# Access Compliance Report

## Public Rights-of-Way

### (Curb Ramps)

Intersection ID: 42756	Main Street: CALDWELL_FOREST_DR	Cross Street: CALDWELL_RIDGE_PY	Location: NE
ADA ID: 5C87A82C88E4	Ramp Type: PerpDiag	Initial Pass/Fail: Fail	Overall Compliance: No
		Severity Score: 50

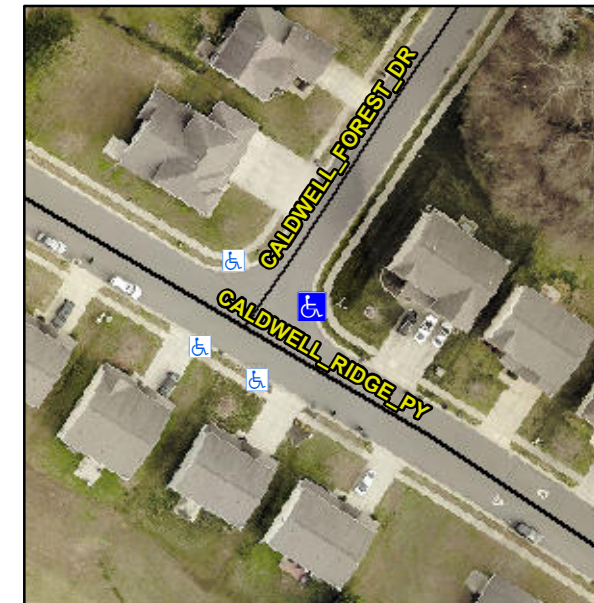
**Not Found, R304.2.2, R304.5.3**

Compliance	Description	Data	Compliance	Description	Data
N/A	Ramp Length (in)	47.0	No	Ramp Slope (%)	13.2
Yes	Ramp Width (in)	56.0	No	Ramp XSlope (%)	7.6
N/A	Flare Type LT	N/A	N/A	Flare Type RT	N/A
N/A	Flare Slope LT (%)	N/A	N/A	Flare Slope RT (%)	N/A
N/A	Flare Traversable LT?	N/A	N/A	Flare Traversable RT?	N/A
N/A	Landing Length (in)	N/A	N/A	DWS Provided?	N/A
N/A	Landing Width (in)	N/A	N/A	DWS Contrast?	N/A
N/A	Landing Slope (%)	N/A	N/A	DWS Length (in)	N/A
N/A	Landing X Slope (%)	N/A	N/A	DWS Full Width?	N/A
N/A	Landing Curb? (Y/N)	N/A	N/A	DWS Offset (in)	N/A
N/A	Shared Landing?	N/A			
N/A	Gutter Ponding?	N/A	N/A	Gutter Slope (%)	N/A
N/A	Gutter Lip Ht (in)	N/A	N/A	Gutter X Slope (%)	N/A
N/A	Painted X Walk1?	No	N/A	Painted X Walk2?	No
	X Walk 1 Direction	To NW		X Walk 2 Direction	To SW
N/A	X Walk 1 Width (in)	N/A	N/A	X Walk 2 Width (in)	N/A
	X Walk 1 Slope (%)	1.6		X Walk 2 Slope (%)	7.0
	X Walk 1 X Slope (%)	5.8		X Walk 2 X Slope (%)	5.9

**Remove & Replace Curb Ramp With Two New Directional Ramps or Equivalent.**
